August 14, 2017

The Environmental Center of San Diego (ECO SD) would like to offer the following comments on the Draft Environmental Impact Report (DEIR) for the Newland Sierra development project in North County.

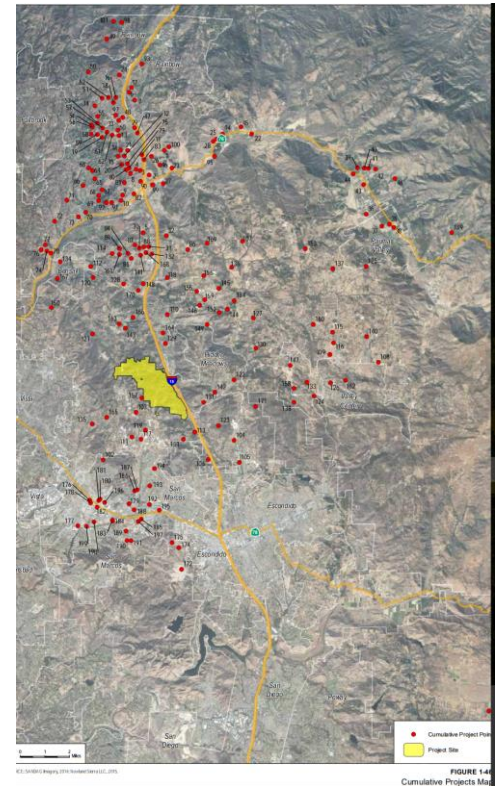
It is puzzling that we could not find any projects from Escondido or Vista on the Cumulative Project Table 1-10. Escondido alone is attempting to build excessive amounts of new sprawl, non-transit oriented development and has proposed or completed several annexations that worsen traffic. Escondido is, essentially, adjacent to this site and all projects in Escondido (or being pursued as annexations) that will feed traffic onto I-15, degrade air quality, raise climate changing gases etc...must be included in this list. Safari Highlands Ranch, Oak Creek, New Urban West/Country Club, and the commercial development at the I-15/Citracado interchange must be added just to name a few. These projects must all be added to the cumulative impacts analysis, analyzed, and included in a recirculated DEIR

Figure 1-46 shows the incompleteness of this issue well. It shows an abundance of cumulative points north of 76 but none in Escondido or Vista—two cities that are proposing significant new projects and loading onto local freeways. This cumulative projects analysis is grossly deficient and must be expanded and redone to be credible.

How close to the freeway are you

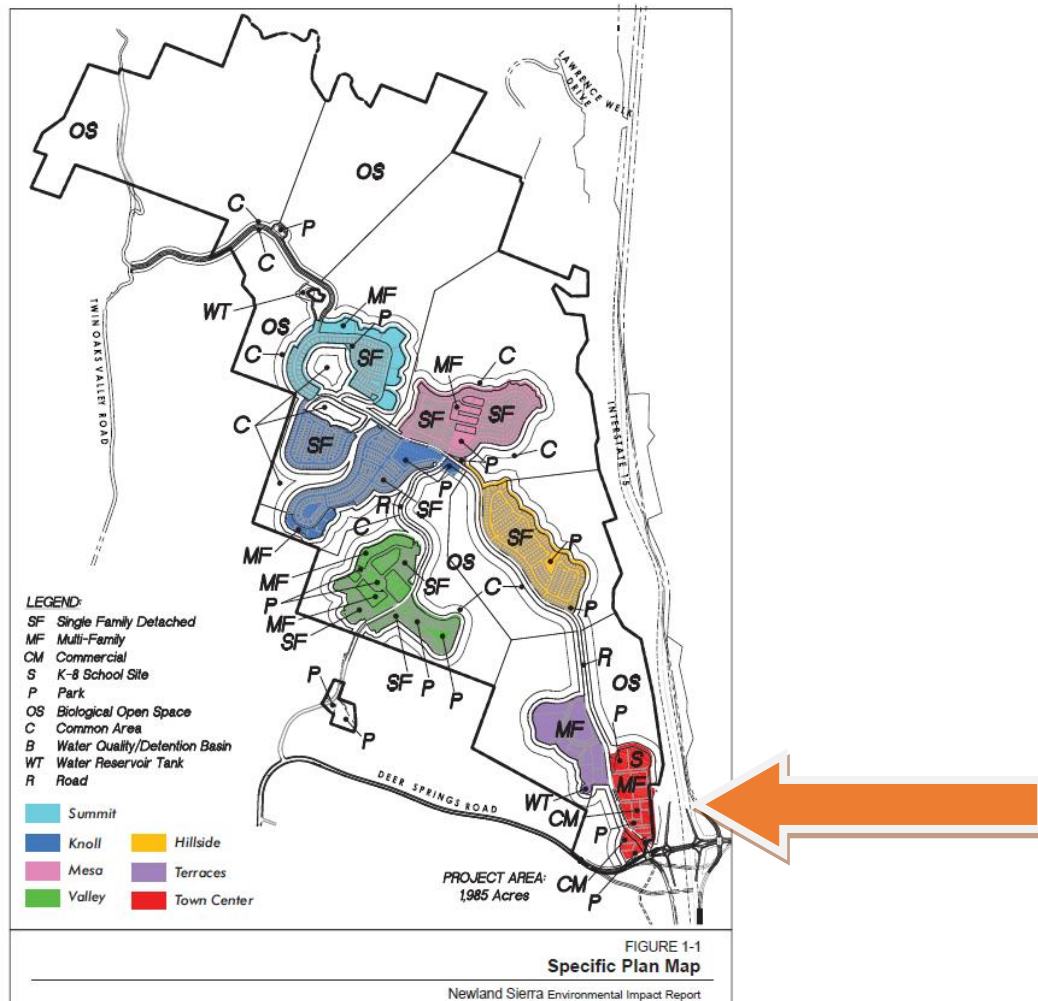
Using the more protective buffer, it appears that school site and homes in the town center must be deleted from the project or moved at least 1,000 feet from the freeway.

To have the best chance of protecting the health of future residents in the project, the project needs to be re-designed to remove all housing from, at least, 1,000 feet from the freeway. While we understand that the ARB document is guidance and not regulation, it is such a significant issue that it would be immoral of the County to approve willingly and knowingly housing and school in this danger zone. This is a significant area of public controversy as well.⁴

In addition, the site design does not comply with the General Plan Policy COS-14.8 which requires projects to *Minimize land use conflicts that expose people to significant amounts of air pollutants*. ECO SD recommends a re-design of the site to removal/relocation of neighborhoods outside of at least 1,000 foot boundary from I-15 in order to meet this policy standard.

The map below shows the area of impact from the freeway with the 500 and 1,000 foot buffers.⁵
